July 14, 2017

ND-17-1085
10 CFR 50.90
10 CFR 52.63

**Southern Nuclear Operating Company
Vogtle Electric Generating Plant Units 3 and 4
Request for License Amendment and Exemption:
Addition of a Residual Heat Removal Suction Relief Valve
for Low-Temperature Overpressure Protection (LAR-17-022)**

COL Appendix C (and plant-specific Tier 1) Figure 2.2.1-1, Containment System

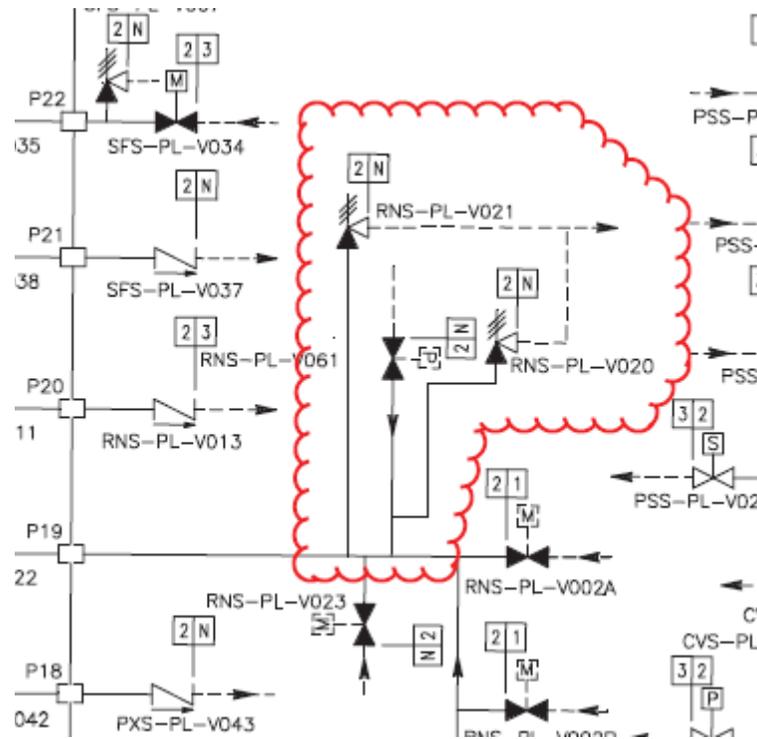
Additionally, Tier 1 Figure 2.2.1-1, for penetration P19, inaccurately depicts the class break for containment isolation valve RNS-PL-V061. The class break is illustrated backwards. Currently, the figure shows the RNS-PL-V061 as nonsafety (N) breaking to Class 2 (2) piping. A change is proposed to reverse the class break depicted on Tier 1 Figure 2.2.1-1 by showing the class break from 2-to-N instead of the current N-to-2, consistent with Tier 1 Figure 2.3.6-1.

- Add RNS relief valve, RNS-PL-V020, and reconfigure piping.
- Revise class break for RNS-PL-V061 from nonsafety (N) to Class 2 (2), to Class 2 (2) to nonsafety (N).

Revise COL Appendix C (and plant-specific Tier 1) Figure 2.2.1-1, Containment System, as shown in the excerpt below, to add RNS relief valve, RNS-PL-V020, and reconfigure piping. Revise class break for RNS-PL-V061 from nonsafety-to-Class 2 (N / 2), to Class 2-to-nonsafety (2 / N).

This figure is revised to add relief valve, RNS-PL-V020. The addition of the RNS relief valve reduces chattering in the current RNS relief valve, RNS-PL-V021, by lifting prior to RNS-PL-V021 during mass input transients. Additionally, the added relief valve, RNS-PL-V020, lifts during mass and heat input transients along with valve, RNS-PL-V021, if pressure exceeds the pressure setpoint for valve RNS-PL-V020. Piping configuration changes accommodate the installation of the added valve. The class break for RNS-PL-V061 is revised from nonsafety to Class 2 (N/2) to Class 2 to nonsafety (2/N) to reflect the change in piping class following the valve. This change is consistent with the class break as shown in Tier 1 Figure 2.3.6-1 and the identification of RNS-PL-V061 as an ASME Code Section III, Class 2 component in UFSAR Table 3.2-3. There are no adverse impacts to the equipment qualification or piping design requirements as RNS-PL-V061 is a safety-related valve and is connected to safety-related piping.

COL Appendix C (and plant-specific Tier 1) Figure 2.3.6-1, Normal Residual Heat Removal System

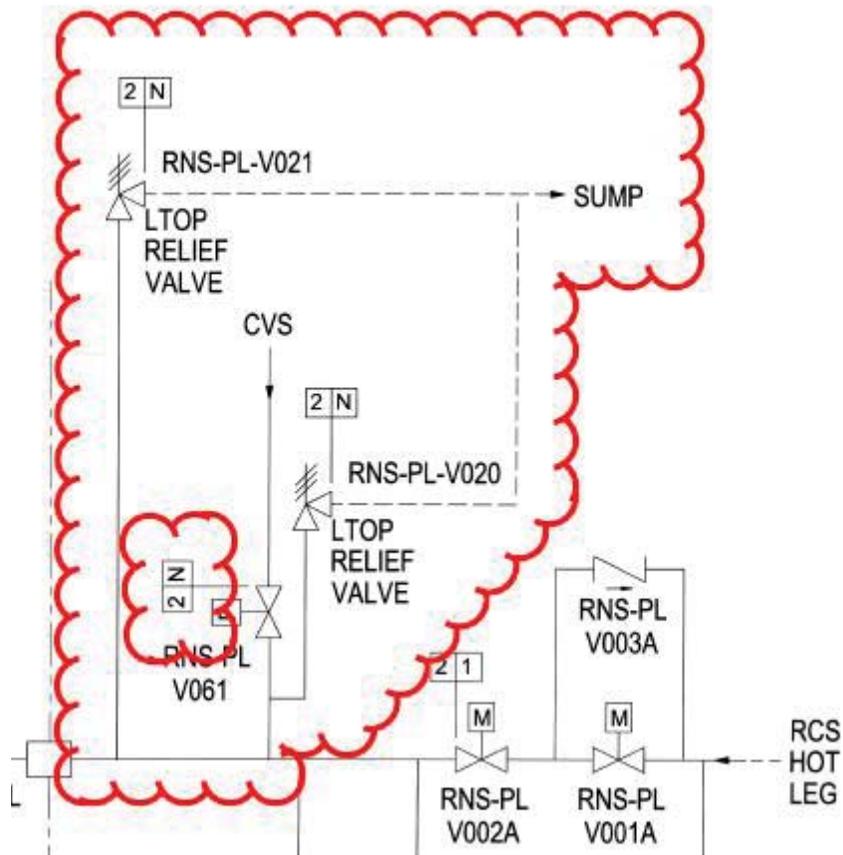
- Add RNS relief valve, RNS-PL-V020, and reconfigure piping.

Revise COL Appendix C (and plant-specific Tier 1) Figure 2.3.6-1, Normal Residual Heat Removal System, as shown in the excerpt below, to add RNS relief valve, RNS-PL-V020, and reconfigure piping.

This figure is revised to add relief valve, RNS-PL-V020. The addition of the RNS relief valve reduces chattering in the existing RNS valve, RNS-PL-V021, and provides stability for LTOP events. Piping configuration changes are made to accommodate the installation of the added valve.

UFSAR Figure 5.4-6, Normal Residual Heat Removal System

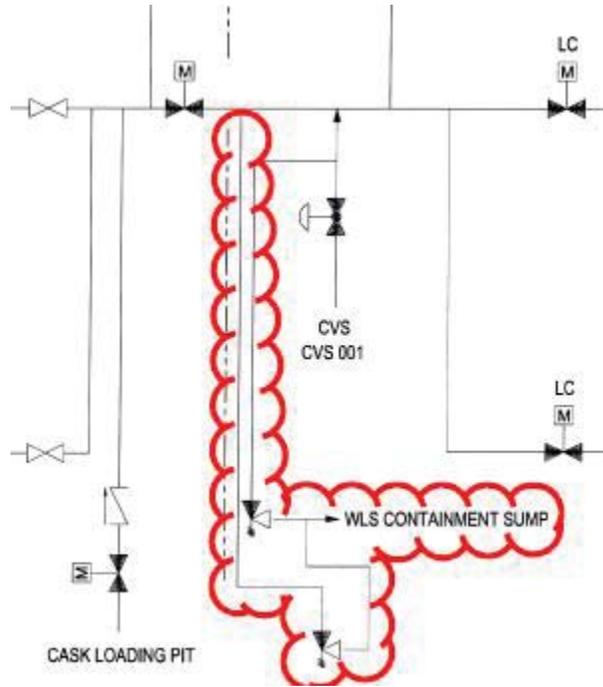
- Add second RNS relief valve which discharges to the WLS containment sump.

Revise UFSAR Tier 2 Figure 5.4-6, Normal Residual Heat Removal System, as shown in the excerpt below, to add second RNS relief valve that discharges to the containment atmosphere.

This figure is revised to illustrate two relief valves. The figure is also revised to indicate that the relief valves discharge to the WLS containment sump instead of containment atmosphere, consistent with UFSAR Figure 5.4-7. The current relief valve piping is reconfigured to accommodate the addition of the added relief valve. There are no adverse impacts to the figure or operation of the current relief valve and RNS as the function of the added relief valve supports the relief and overpressure protection of the RNS and RCS. The addition of RNS relief valve, RNS-PL-V020, reduces chattering in the existing RNS valve, RNS-PL-V021, and provides stability for the LTOP events.

UFSAR Figure 5.4-7, Normal Residual Heat Removal System Piping and Instrument Diagram

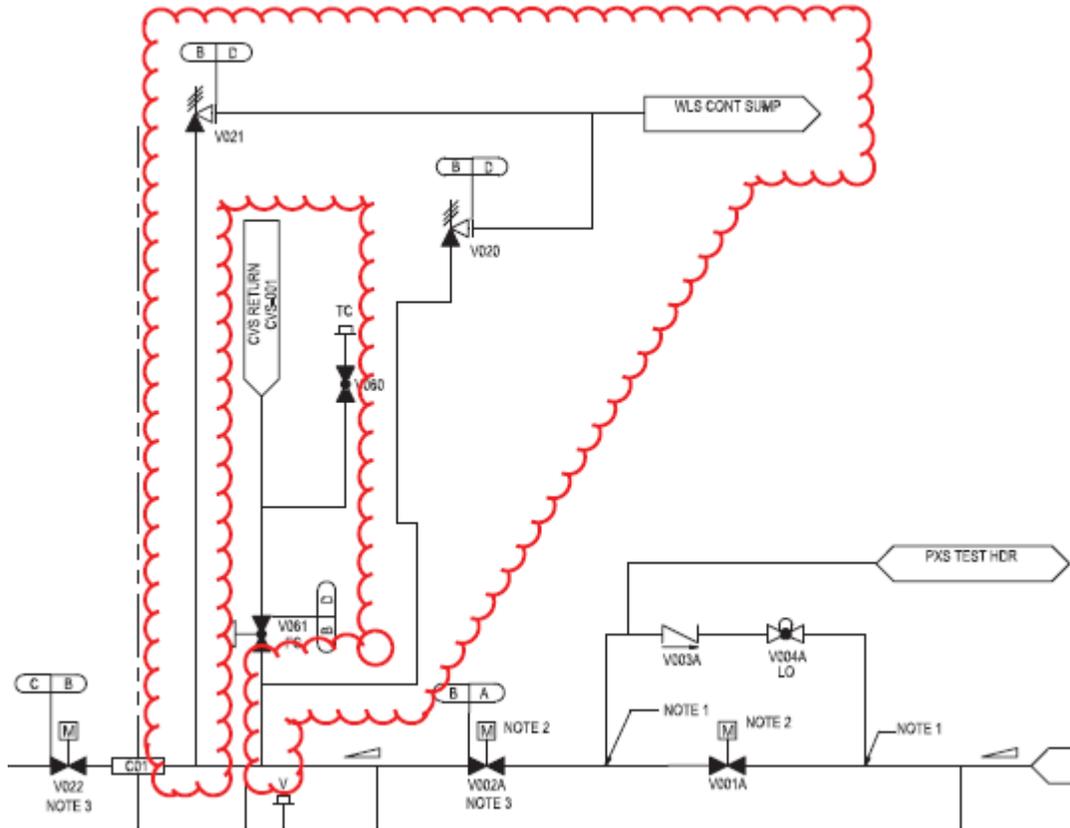
- Add RNS relief valve, RNS-PL-V020, and reconfigure piping.

Revise UFSAR Tier 2 Figure 5.4-7 Simplified Normal Residual Heat Removal System Piping and Instrument Diagram, as shown in the excerpt below, to add RNS relief valve, RNS-PL-V020, and reconfigure piping.

This figure is revised to add RNS relief valve, RNS-PL-V020. Piping for the current relief valve, RNS-PL-V021, is reconfigured to accommodate the installation of the added relief valve, RNS-PL-V020. There are no adverse impacts to the figure or operation of the existing relief valve and RNS as the function of the added relief valve supports the relief and overpressure protection of the RNS and RCS. The addition of the RNS relief valve reduces chattering in the current RNS relief valve, RNS-PL-V021, and provides stability for the LTOP events.
